Project
ATTENUATION
PONDS

PRELIMINARY					DETAILS	
REV.	NO.	DATE	DESCRIPTION			
1	1					
Client				MJA CONSULTING		
Project				Manor Farm		
Site				Denville		
Title				Drainage sections		
Scale				As shown		
Drawing No.				4527/71		
Drawing Date				Mar 13		
Drawing By				RTG

Pre-application Enquiry

Flood Risk Assessment

TYPICAL SECTION THROUGH IMPERMEABLE ATTENUATION POND
Scale 1:20

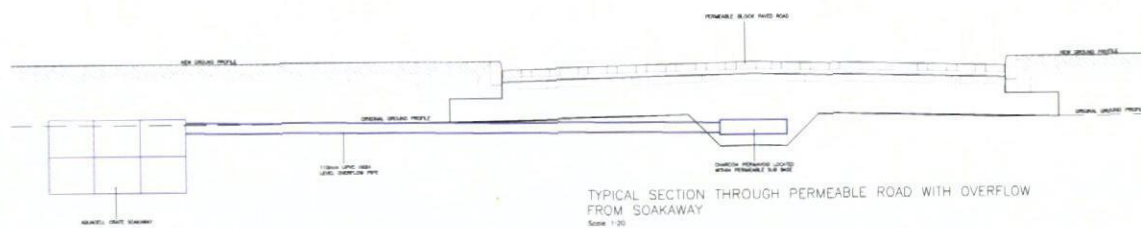
The proposed ground raising and potential for groundwater infiltration was also discussed at the meeting following the previous points raised by us in response to Revision E of the FRA (our reference: HA/2013/113856/03). To save any misunderstanding MJA Consulting or Barratt Homes should confirm if the ponds are to be built in areas of raised land or if only the proposed housing would be raised up. An indicative cross-section of the ponds and development showing the soakaway-overflow/collector cell-pond arrangement would be useful.

Please refer to Appendix G, drawing 4527:71 for an indicative cross section of the ponds in relation to the development.
